BROWNS FERRY NUCLEAR PLANT (BFN) – UNITS 1, 2, AND 3 – TECHNICAL SPECIFICATIONS (TS) CHANGES TS-418 AND TS-431 – EXTENDED POWER UPRATE (EPU) – RESPONSE TO ROUND 23 REQUEST FOR ADDITIONAL INFORMATION (RAI) REGARDING STEAM DRYER SIGNAL PROCESSING (TAC NOS. MD5262, MD5263, AND MD5264)

**TENNESSEE VALLEY AUTHORITY
BROWNS FERRY NUCLEAR PLANT (BFN)
UNITS 1, 2, AND 3**

**TECHNICAL SPECIFICATIONS (TS) CHANGES TS-431 AND TS-418
EXTENDED POWER UPRATE (EPU)**

**RESPONSE TO ROUND 23 REQUEST FOR ADDITIONAL INFORMATION (RAI)
REGARDING STEAM DRYER SIGNAL PROCESSING**

Figure EMCB.203-1.19a: Phase of coherence filtered data for BFN1 main steam line A (top) and B (bottom), for CLTP conditions (black) and LF conditions (blue).

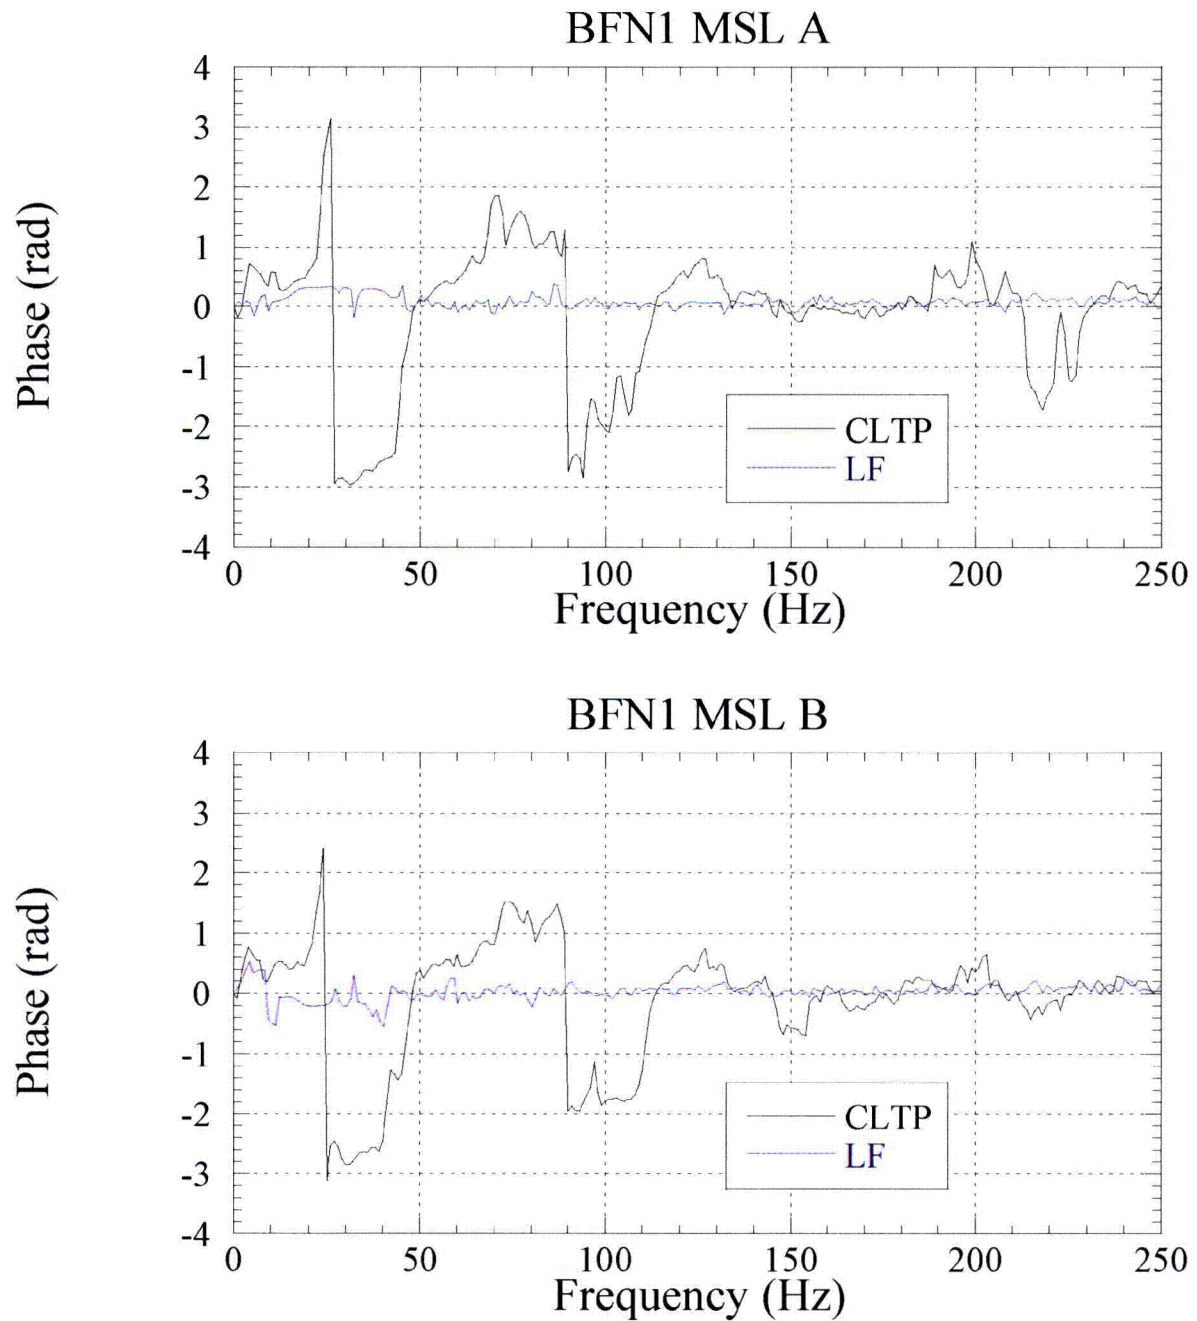
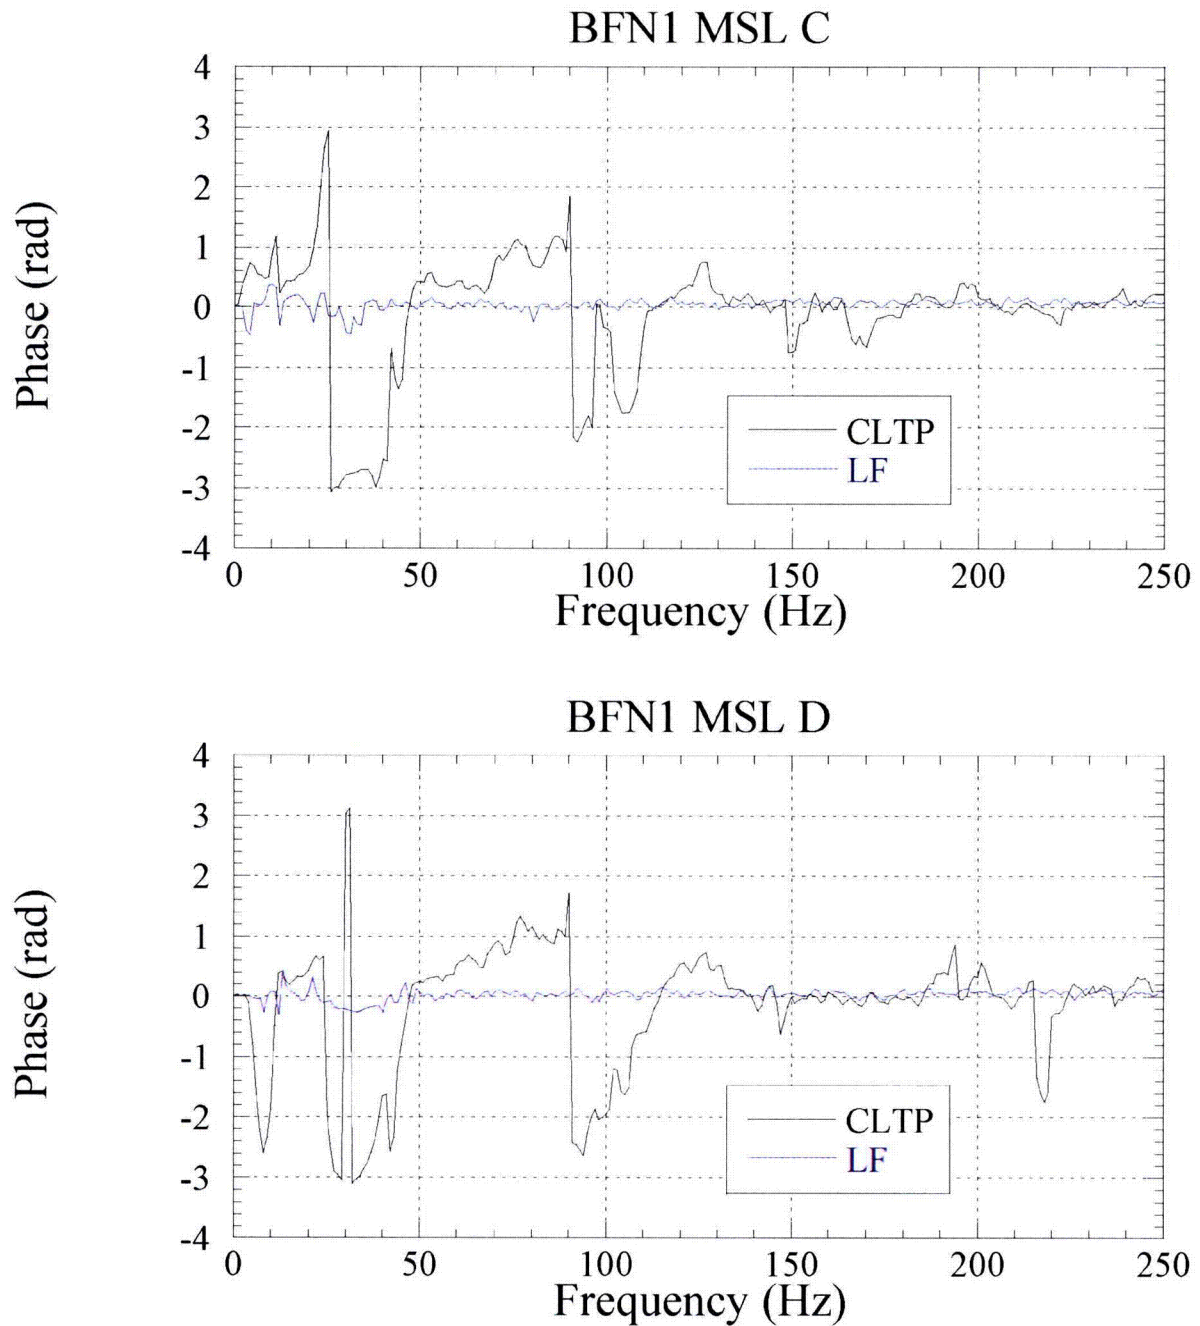
In response to EMCB.200/157., TVA presents detailed discussion of signal conditioning in six steps. Provide plots of strain gage signals (autospectra, cross spectra, coherence, and phase) and computed [[]] throughout the procedure described in their RAI response (prior to step 1, after step 1, after step 2, after step 4 and after step 6), for current license thermal power (CLTP) and Low Flow (LF) signals, for Units 1 and 2.

After Step 4: apply coherence and mean filter
